WORK TO BE PERFORMED UNDER THIS PROJECT INCLUDES THE CONSTRUCTION OF A NORTHBOUND LEFT TURN LANE, AND INSTALLING A SIGNALIZED TRAFFIC SYSTEM, WITH RELATED PAVEMENT MARKINGS AND SIGNS.

CONTRACTOR: ENGINEERS CONSTRUCTION, INC. - SO. BURLINGTON, VT
RESIDENT ENGINEER: T. POCKETTE
CONSTRUCTION BEGAN: JULY 5, 2005
CONSTRUCTION COMPLETE: NOVEMBER 13, 2005
RECORD PLANS BY: T. POCKETTE & N. GARBACIK

PROJECT NAME : **CLARENDON**
PROJECT NUMBER : **NHG SGNL (24)**

PAVEMENT MARKING LAYOUT SHEET

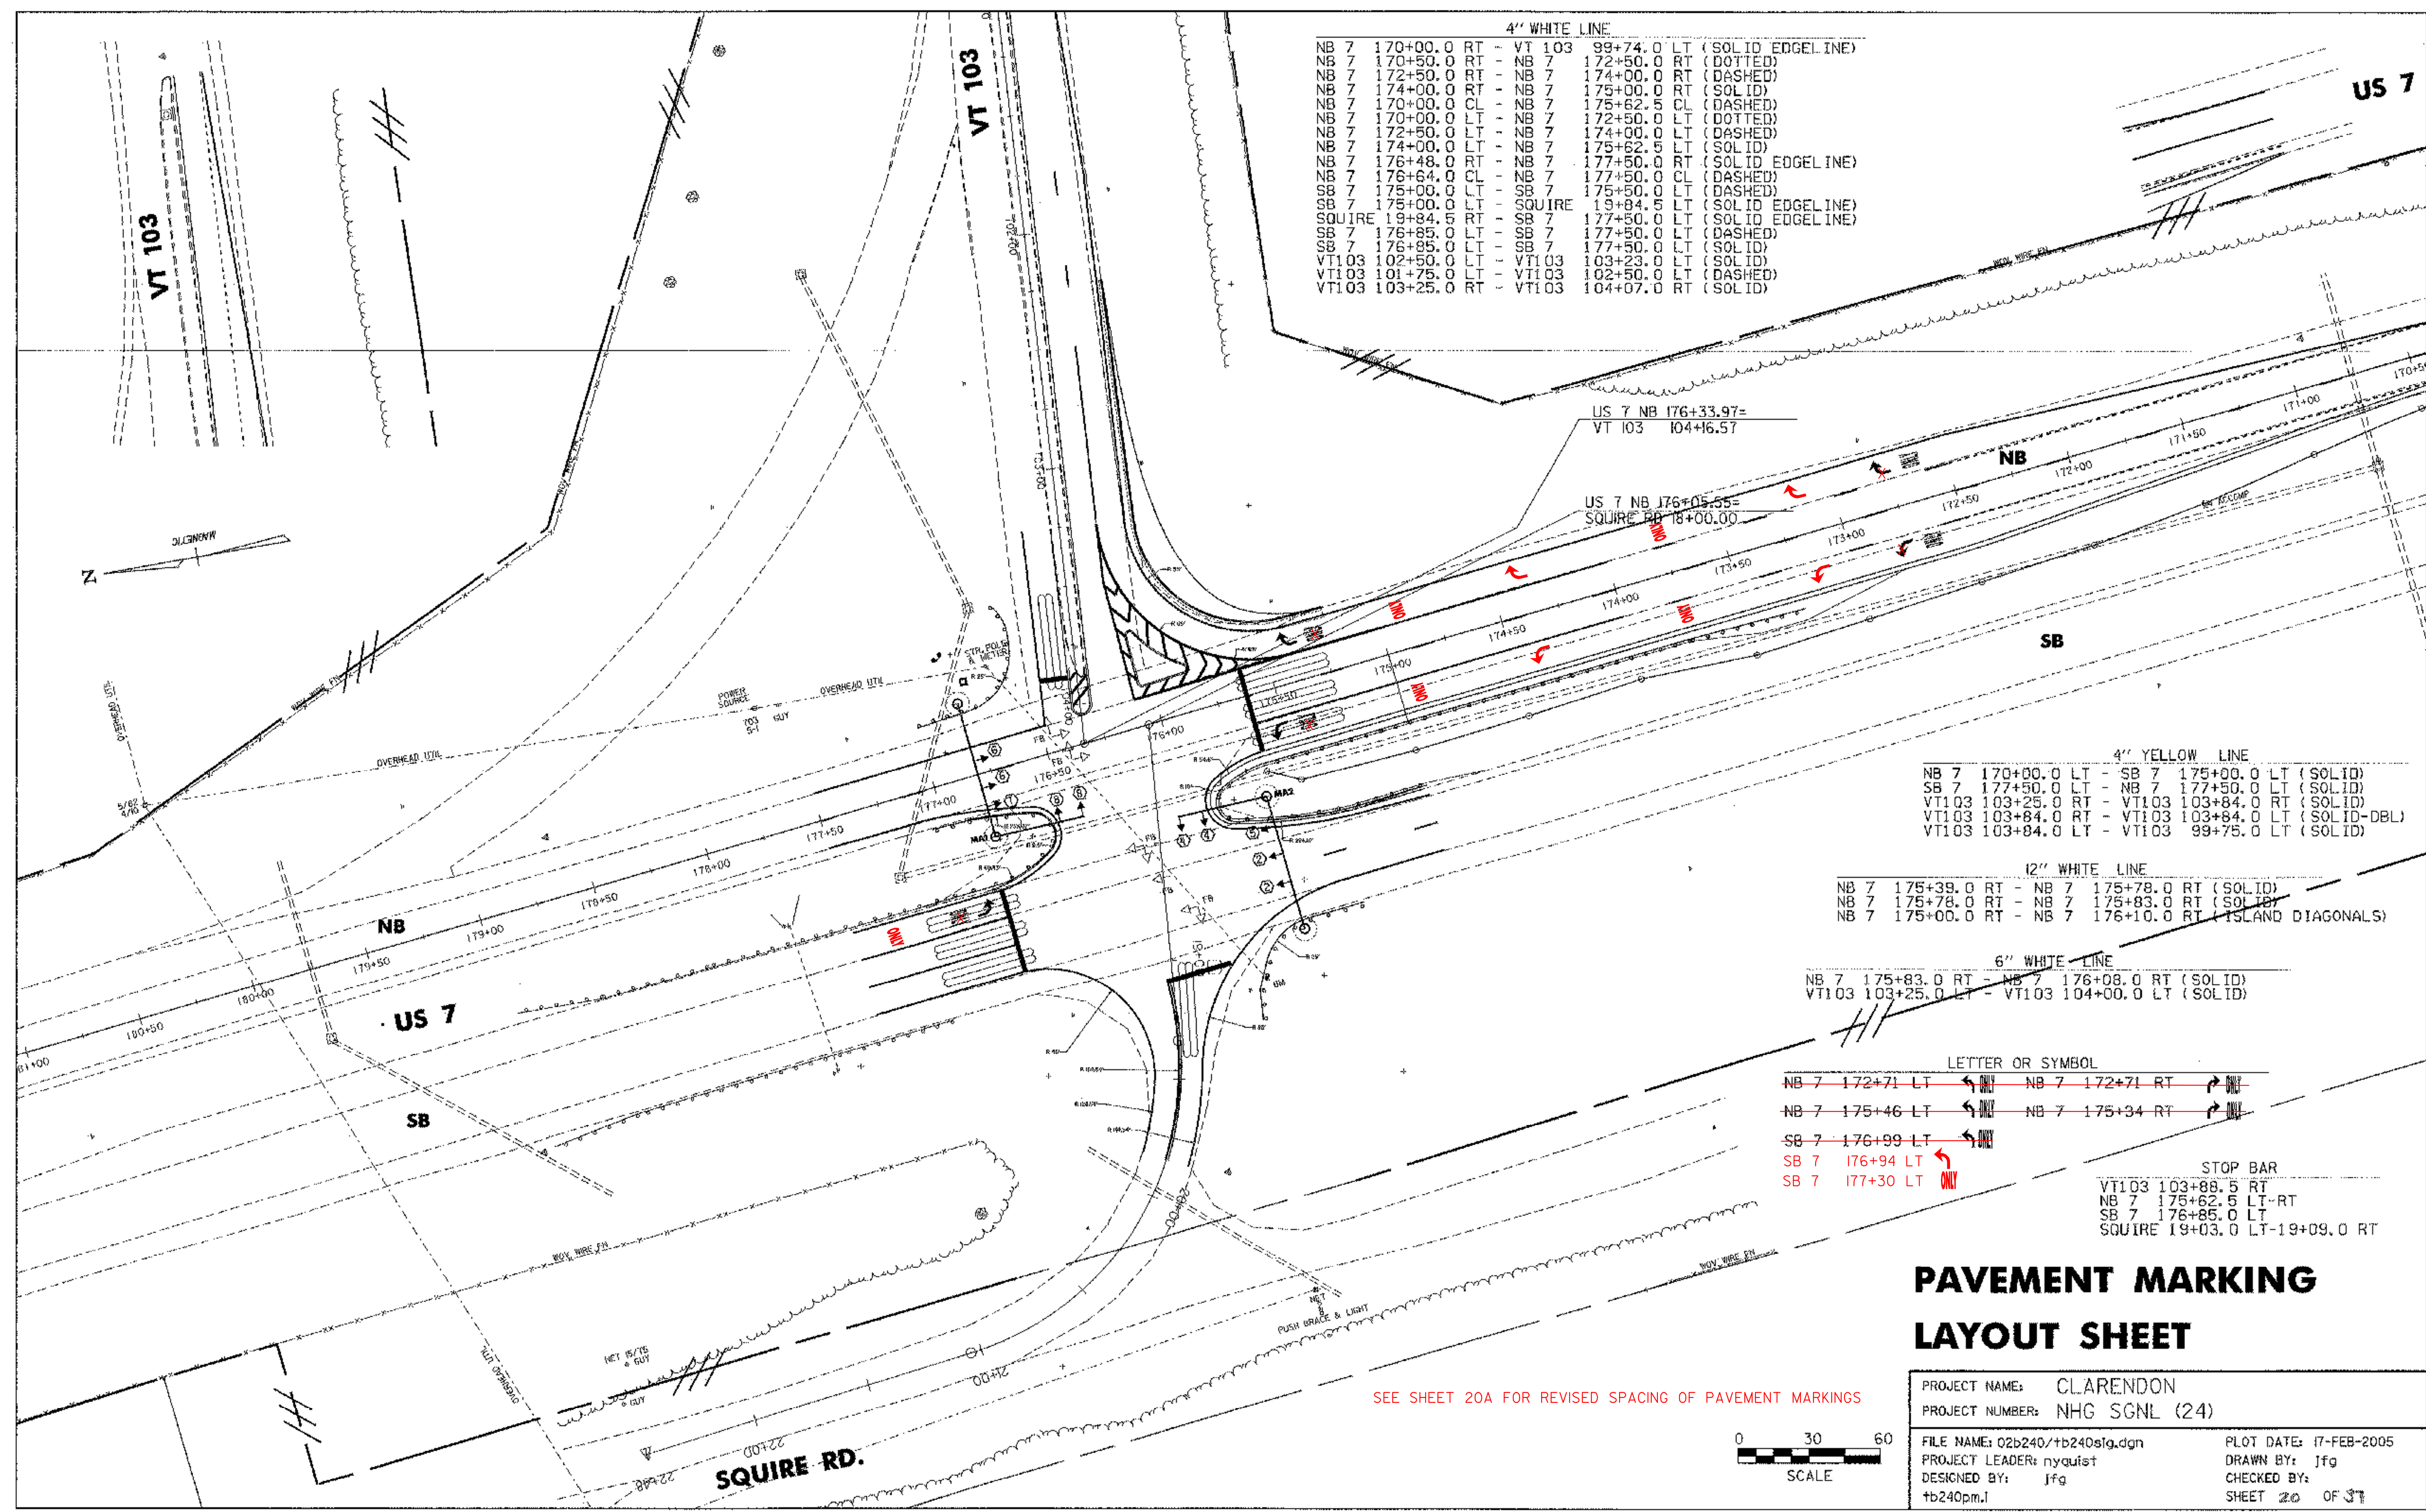
SEE SHEET 20A FOR REVISED SPACING OF PAVEMENT MARKINGS

CLARENDON NHG SGNL (24)
WRITE ORDER #11 ATTACHMENT

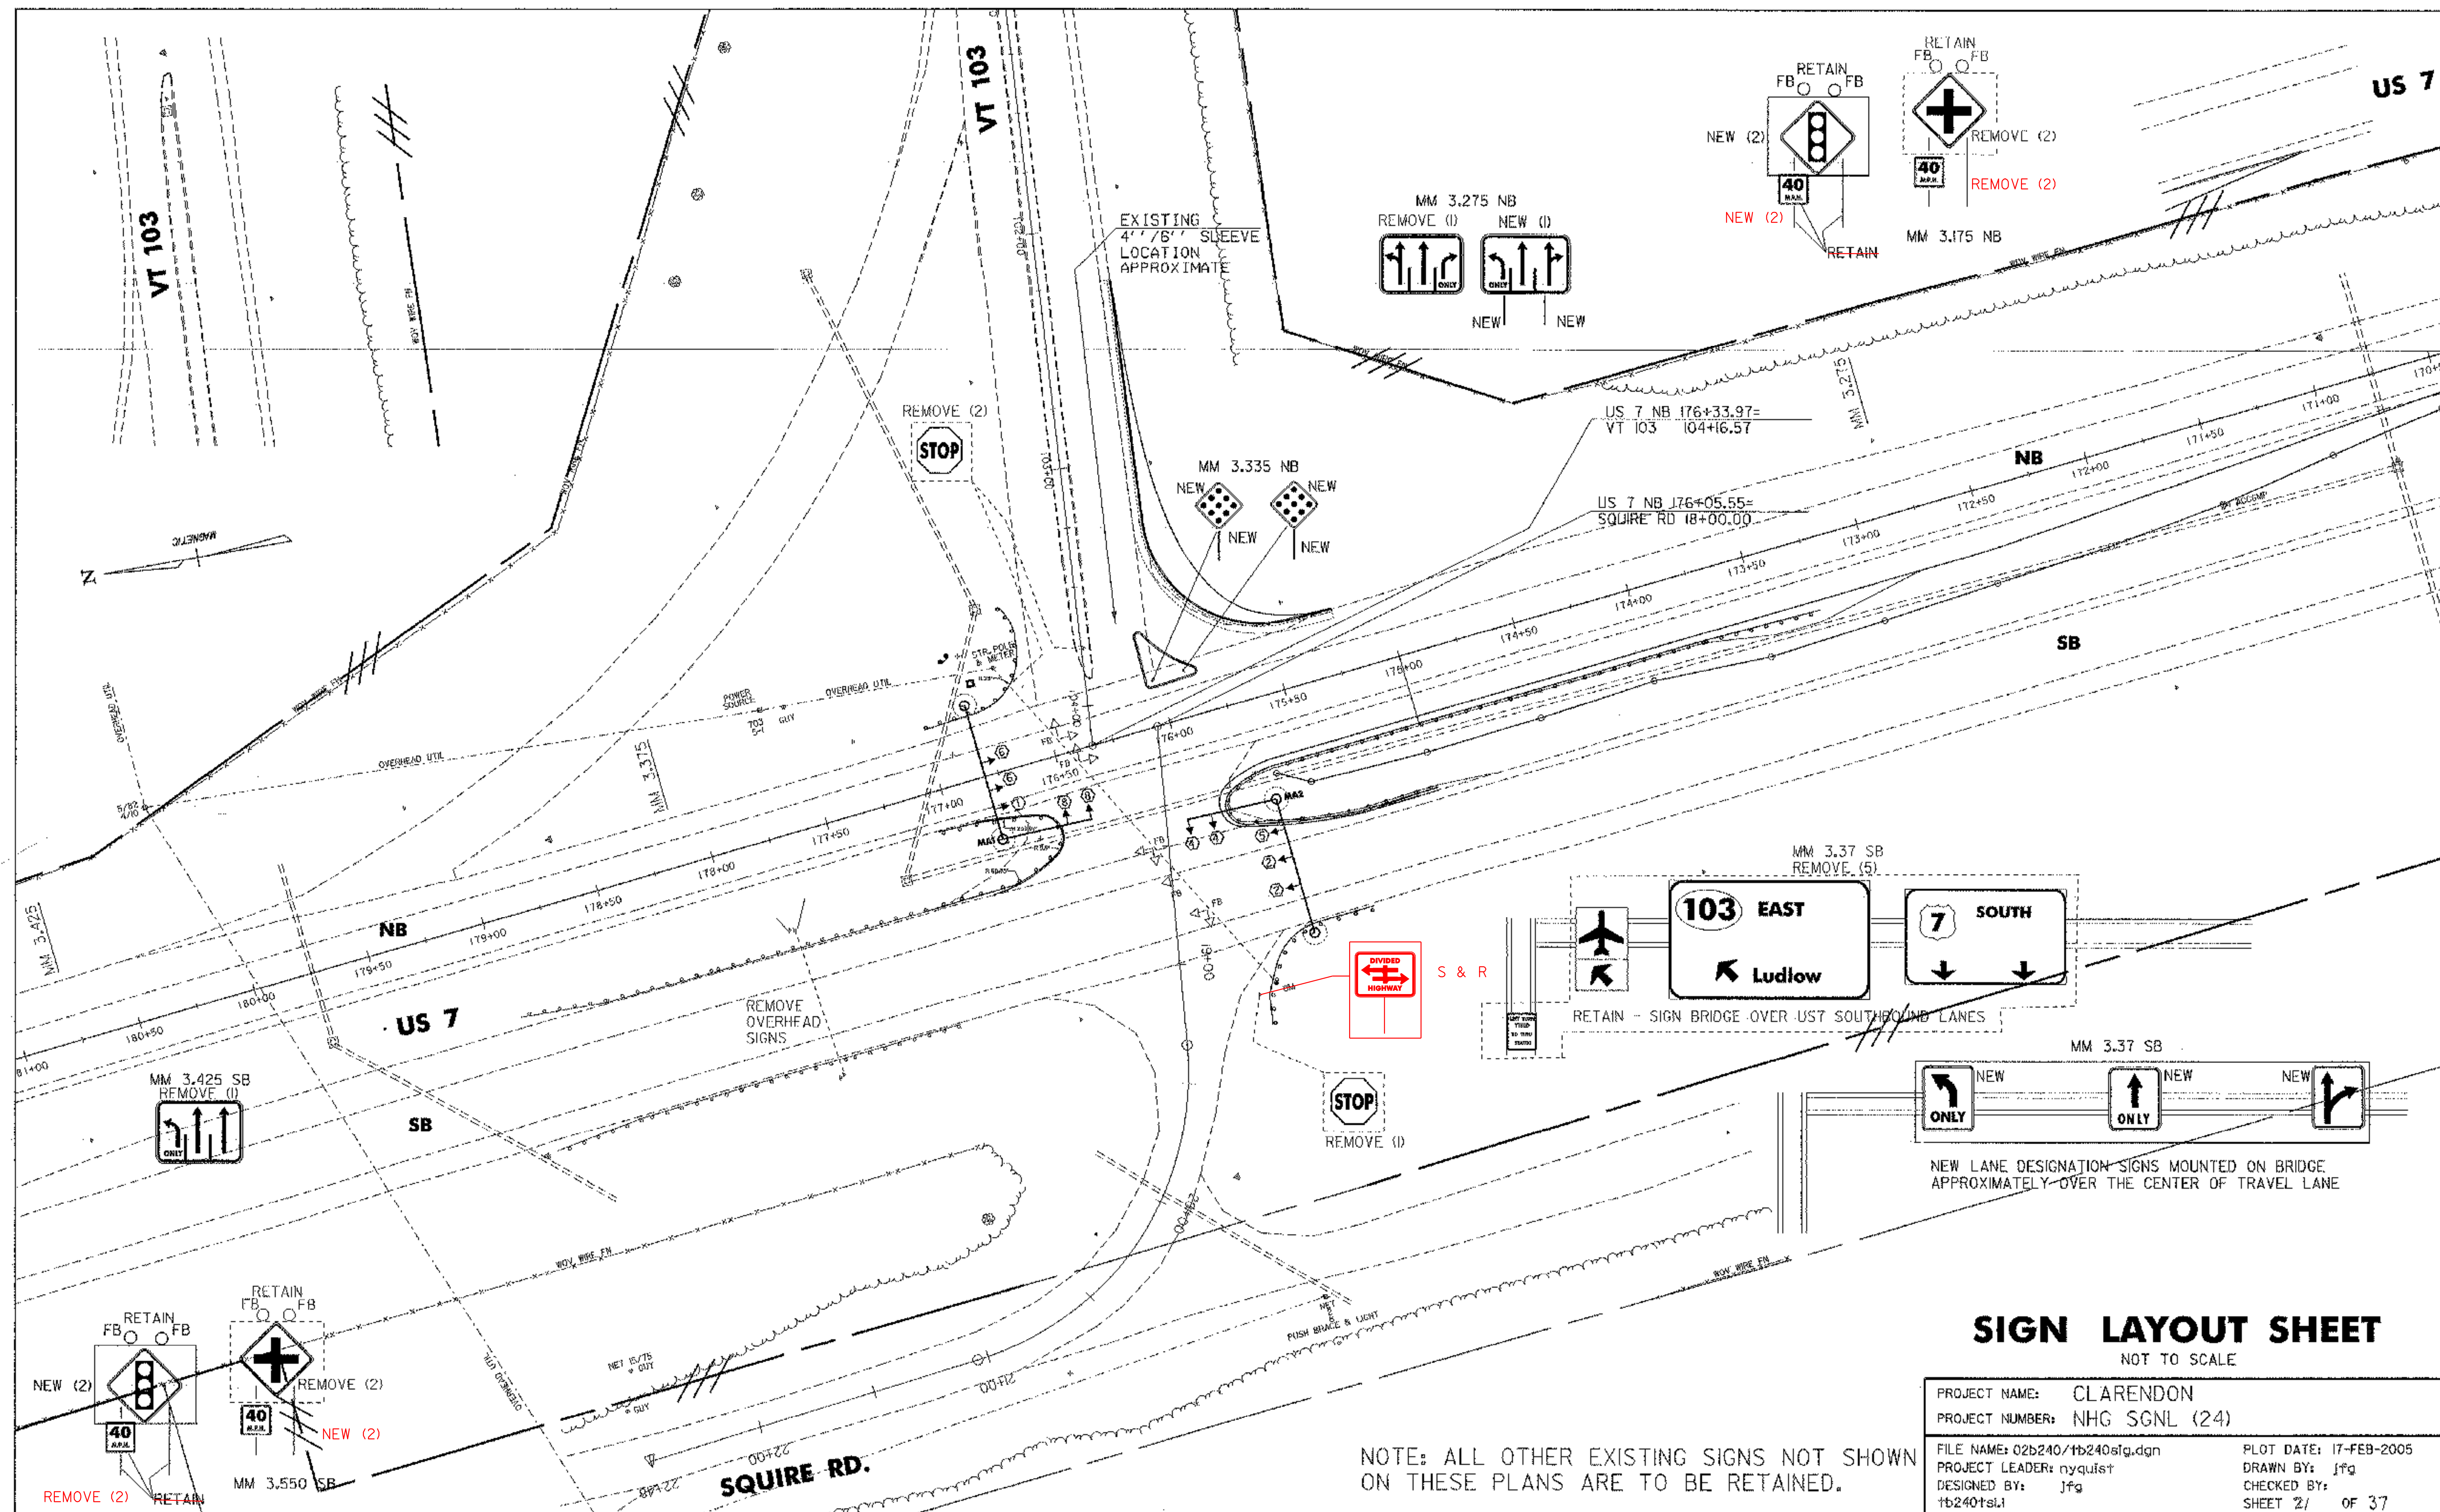
Changes Per WO #11
09-07-03
7D
